REFERENCE:	Nova Bus Manuals
SECTION:	11: DPF with SCR exhaust system
RS N°:	MQR 7621-736
EFFECTIVE IN PROD.:	L749 (2014FE)

SUBJECT:	Exhaust system flexible joint bellows
JUSTIFICATION:	Soot leak at exhaust system flexible joint bellows.

Figure 2 - Flexible Joint Bellows Assembly

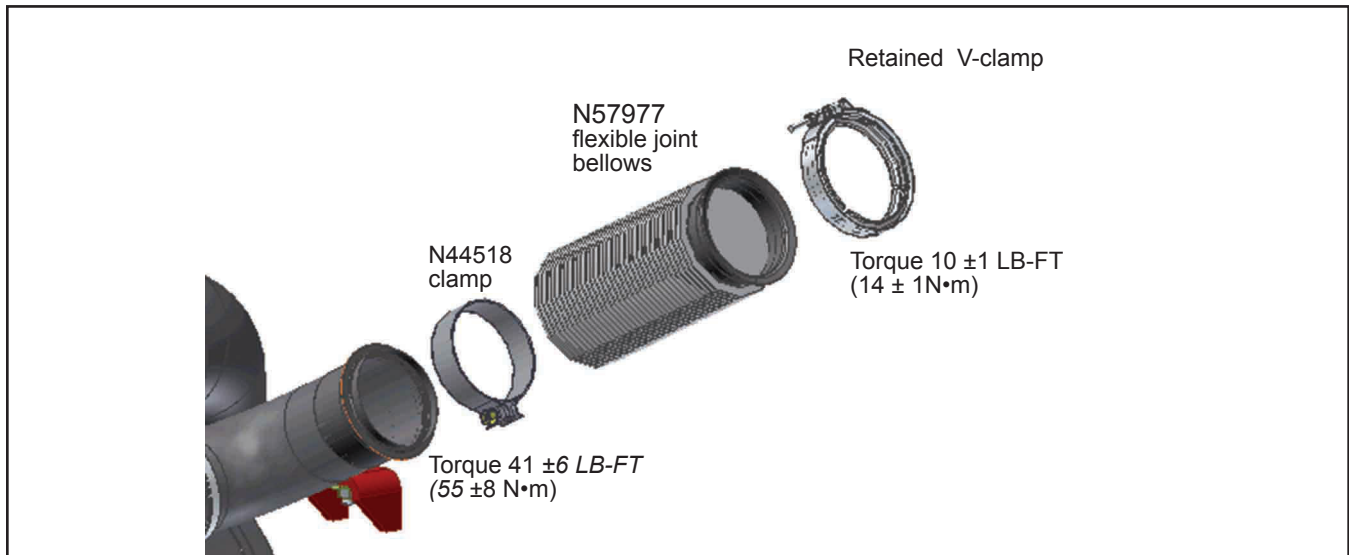
- 1.5. Slide the new N44518 clamp onto the bellows.
- 1.6. Install the retained clamp to the flexible joint turbo charger.
- 1.7. Attach the first section of the flexible joint to the turbo charger with the retained V-clamp.

- 1.10. Tighten to the torque specified in Figure 2.
- 1.11. Install the retained fabric heat shield.
- 1.12. Close the rear engine door. ❖

Figure 3 - N44518 Clamp Installation

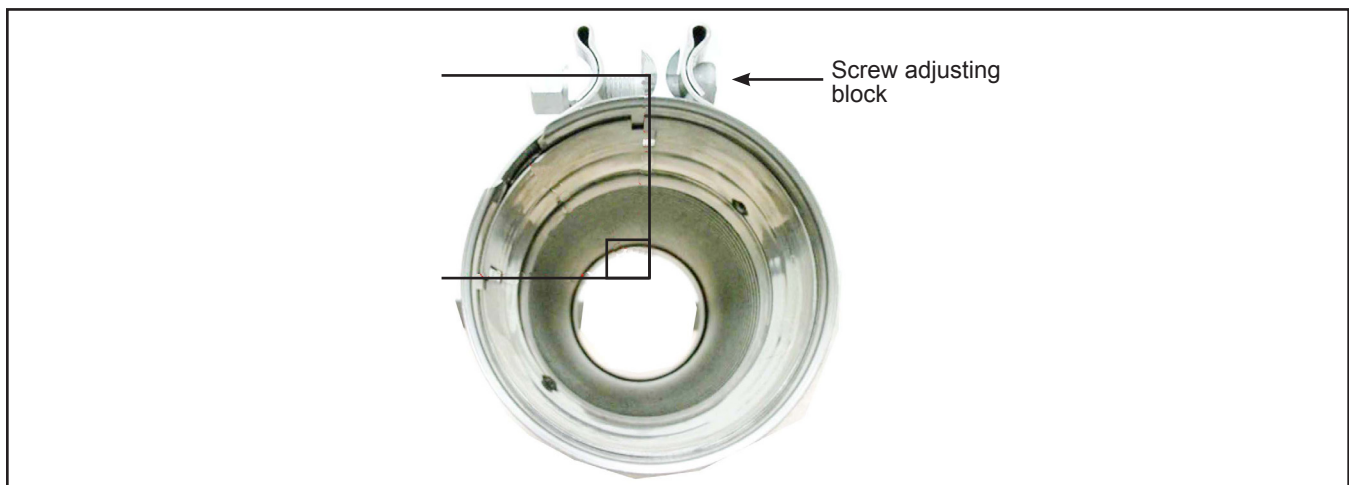
- 1.8. Attach the second section of the flexible joint to the exhaust pipe/DPF inlet. Make sure that you do not stress the flexible joint between the two sections.
- 1.9. Align the screw adjusting block of the N44518 clamp to a seal slot. The flat clamp should always point toward the other seal slot located 90° away.
